Contract #: 04-0120F4Cty: SF/ALA Rte: 80 PM: 13.2/13.9File #: 69.25B**QUALITY ASSURANCE -- NON-CONFORMANCE REPORT****Location:** Changxing Island, Shanghai, P.R. China**Report No:** NCR-000496**Prime Contractor:** American Bridge/Fluor Enterprises, a JV**Date:** 28-Oct-2009**Submitting Contractor:** Zhenhua Port Machinery Company, Ltd (ZPMC), Changxing Island**NCR #:** ZPMC-0469**Type of problem:****Welding****Concrete****Other****Welding****Curing****Procedural****Bridge No:** 34-0006**Joint fit-up****Coating****Other****Component:** Segment 6AW**Procedural****Procedural****Description:** Found MT indications after Contractor's acceptance**Reference Description:** Crater and Linear Indications discovered in 6AW with MT after the contractor's NDT acceptance**Description of Non-Conformance:**

**NON-CONFORMANCE REPORT TRANSMITTAL**

<b>To:</b>	AMERICAN BRIDGE/FLUOR, A JV 375 BURMA ROAD OAKLAND CA 95607	<b>Date:</b>	11-Dec-2009
<b>Dear:</b>	Mr. Charles Kanapicki	<b>Contract No:</b>	04-0120F4 04-SF-80-13.2 / 13.9
<b>Attention:</b>	Mr. Thomas Nilsson Project/Fabrication Manager	<b>Job Name:</b>	SAS Superstructure
<b>Subject:</b>	NCR No. ZPMC-0469	<b>Document No:</b>	05.03.06-000459

**

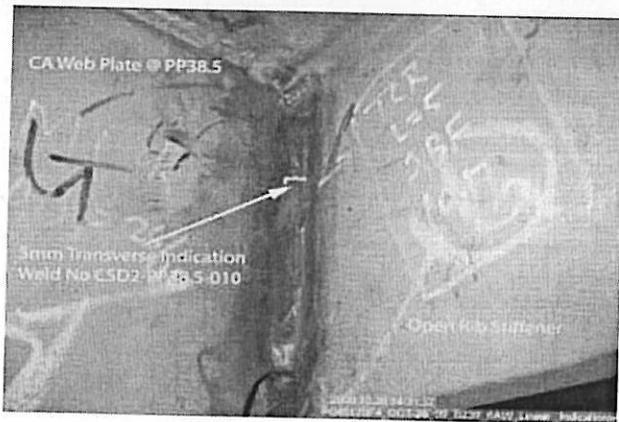
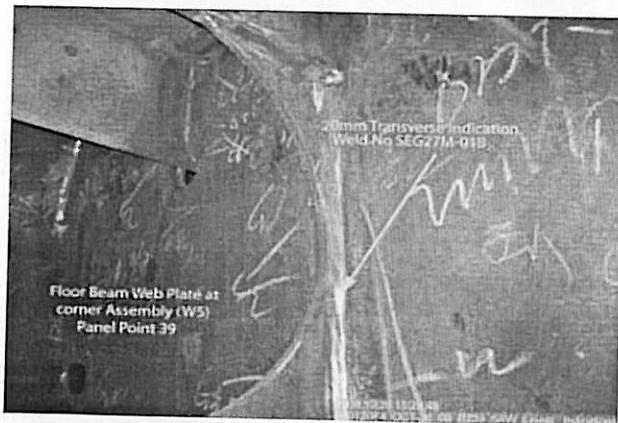
During a random Magnetic Particle (MT) verification of OBG Segment 6AW, the Caltrans Quality Assurance (QA) Inspectors observed fifteen (15) Crater Indications on the Deck Panel U rib to Diaphragm welds at panel point 38 and 39. The Crater Indications ranged from 10mm to 30mm in length and these welds were tested and accepted by ZPMC QC MT.

The following weld designations and length of indications were observed.

DP084-001-059 (10mm), DP111-001-067 (30mm), 062 (30mm), 059 (20mm), 092 (10mm) DP165-001-086 (20mm), DP273-001-056 (20mm), 051 (20mm), 048 (30mm), 038 (20mm), 084 (20mm) DP246-001-094 (30mm), 081 (15mm), 065 (10mm), 060 (10mm).

During a random verification Magnetic Particle Testing of the internal components of OBG segment 6AW, the Caltrans Quality Assurance (QA) Inspector discovered a total of two (2) Transverse Indications that measured from 5mm to 20mm in length. These welds were previously tested accepted by ZPMC (MT) technicians. The non-complying weld designations are as follows:

Open Rib Stiffener to corner assembly web plate weld- CSD2-PP38.5-010 (1) 5mm Transverse Indication.  
 Longitudinal Girder to panel point 38 Weld -SEG027M-018 (1) 20mm Transverse Indication.
